**REMARKS**

"Annotated Marked-Up Drawings"

FIG 1

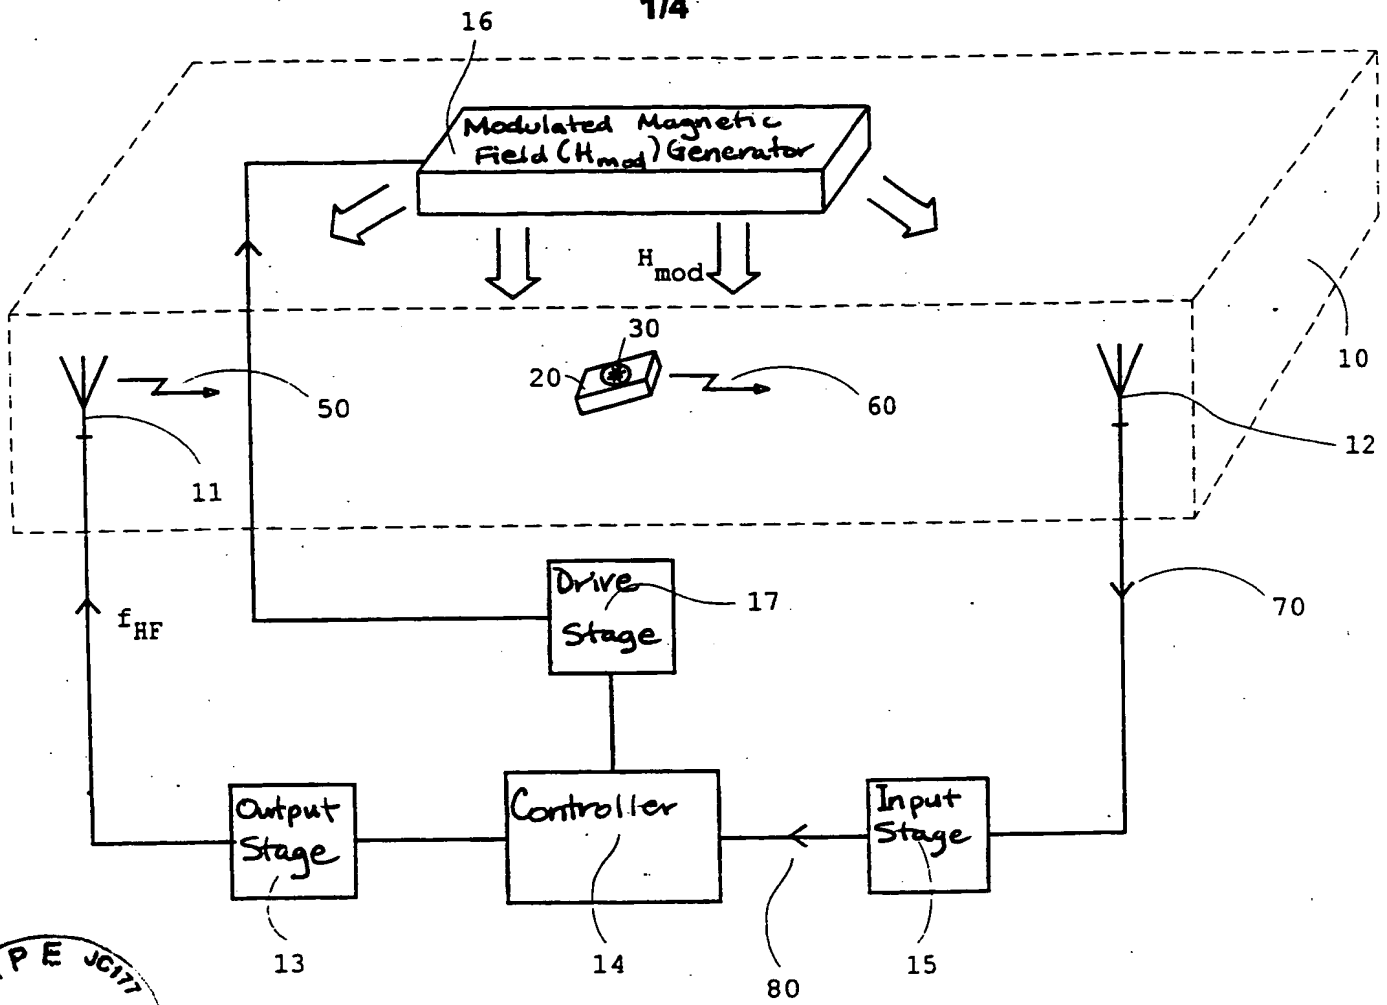
The drawings stand objected to as failing to comply with 37 C.F.R. §1.84 with the Examiner requires that descriptive labels be added to the function docks in Figure 1. A proposed drawing correction submitting functional labels for the blocks in Figure 1 is attached. Approval of the drawing correction is respectfully requested.
